Development Facilitation Team (DFT) – Review Comments

DRB Project No: PR-2020-003484 Date: 05/10/2023 Agenda Item: #4 Zone Atlas Page: E-10

Application For: SD-2023-00048 – PRELIMINARY PLAT (DHO)

DRB Project Number: 2020-003484 Hearing Date: **05-10-2023**
 Project: Mojave Ridge Subdivision Agenda Item No: **4**

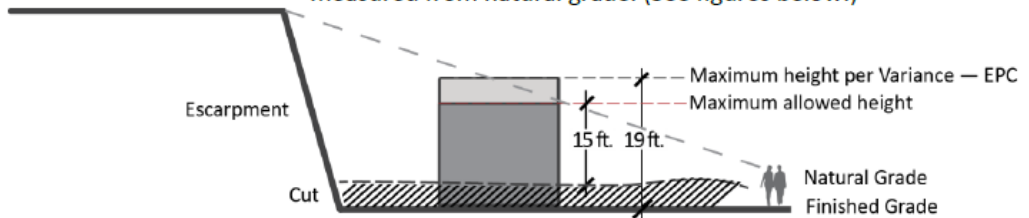
Change the maintenance note of Tract A (pond) to be the Homeowner's Association; city maintenance is not provided for Tract A.

3-6(E)(3) Building and Structure Height

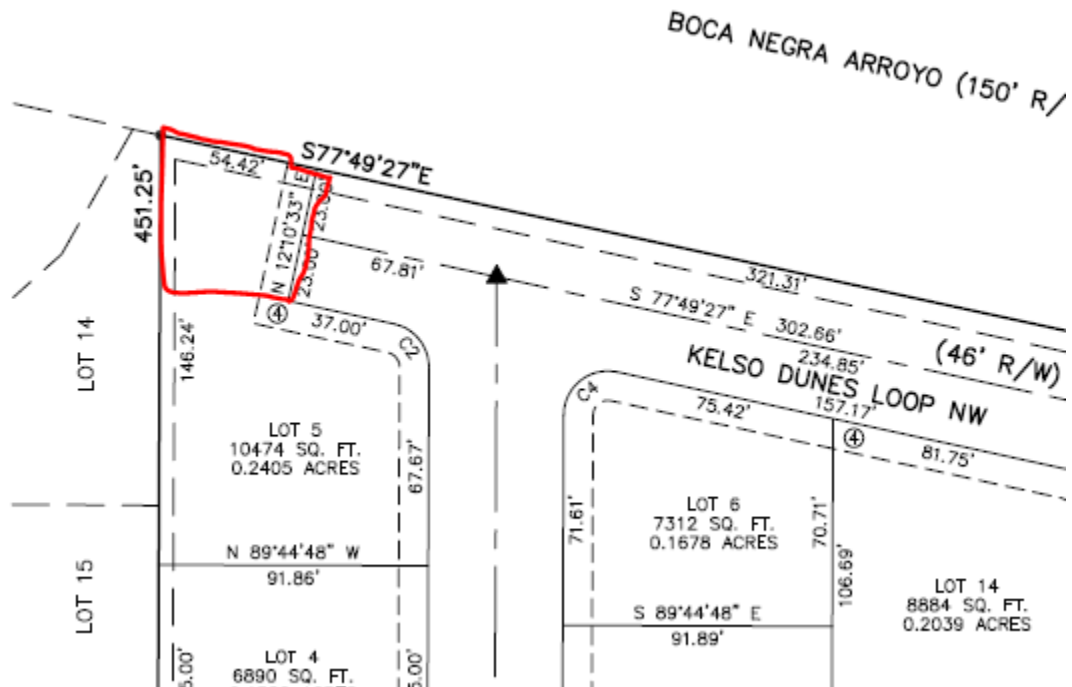
- **IDO 3-6(E) The parcels are in the VPO-2 Height Restricted Sub Area. Identify the allowable structure height vis a vis grading plan.** 'Building and/or structure height shall not exceed 15 feet, as measured from natural grade.'

***Show height measurements from finished grade and natural grade. *Clarify if standards are being met.**

3-6(E)(3)(a) Building and/or structure height shall not exceed 15 feet, as measured from natural grade. (See figures below.)
